From: Altmayer, Scott A [alitmaysa@westinghouse.com]
Sent: Tuesday, June 29, 2010 1:31 AM
To: Buckberg, Perry; Patel, Pravin
Cc: Stipanovich, Steven M; Loza, Paul G.; Morrow, Robert J.; Ritterbusch, Stanley E; Sanders, Mitchell P.; Bob Hirmanpour (bobhirman@live); Gary Becker; Mike Fanguy; David Waters (David.Waters@pgnmail.com)
Subject: New Fuel Rack RAIs - per Non-credible "drop" position
Attachments: OI-SRP9.1.4-SBPA-03 R3A NRC final draft.doc; RAI-TR44-01 R1C NRC final draft.doc; RAI-TR44-06 R2B NRC final draft.doc; RAI-TR44-08 R2B NRC final draft.doc; NFR-DCD noncredible.doc

Subject: New Fuel Rack RAIs - per Non-credible "drop" position
Sent Date: 6/29/2010 1:31:08 AM
Received Date: 6/29/2010 1:31:19 AM
From: Altmayer, Scott A

AP1000 TECHNICAL REPORT REVIEW

RAI Response Number: OI-SRP9.1.4-SBPA-03
Revision: 32A

~~Figure 2-10 Baseplate Deformation Resulting from Fuel Assembly Drop onto Baseplate (2.41 inch Maximum Displacement Directly under Impact Location) (Removed by Revision 2B)~~

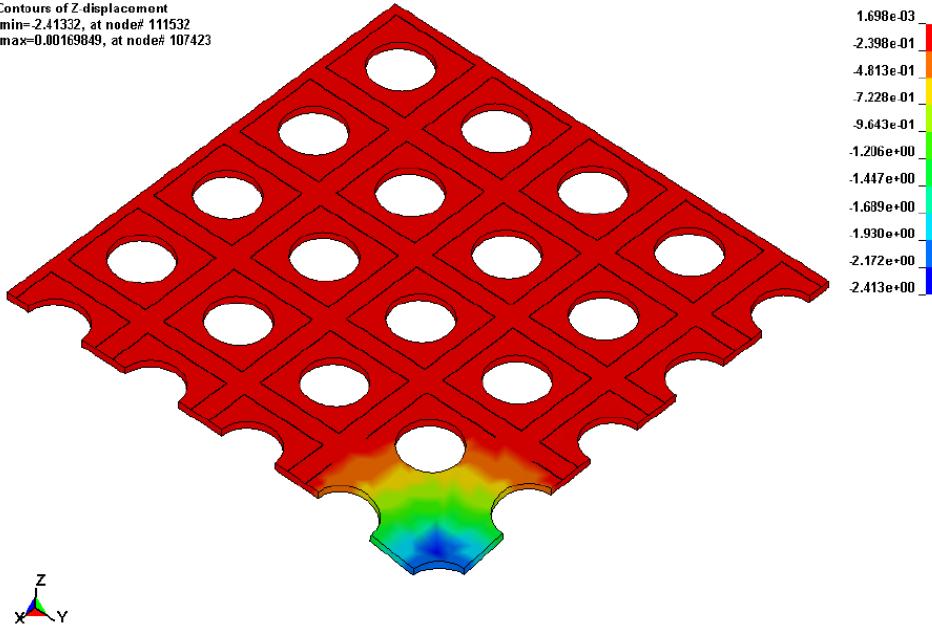
Based on the non-credible nature of the new fuel assembly drop accident, the next revision of TR44 will remove all detailed discussions, tables, and figures that reference applicability of the new fuel pit drop accident scenarios. This information will be retained in the legacy analysis (Reference 2).

The figure change below from Revision 1 is obsolete. The next revision of TR44 will remove all detailed discussions, tables, and figures that reference applicability of the new fuel assembly pit drop accident scenarios.

Figure 2-10 of TR44 was revised to reflect the updated results of the drop analysis; see the Technical Report Revision section for details.

Yes. Figure 2.10 was replaced by the following figure.
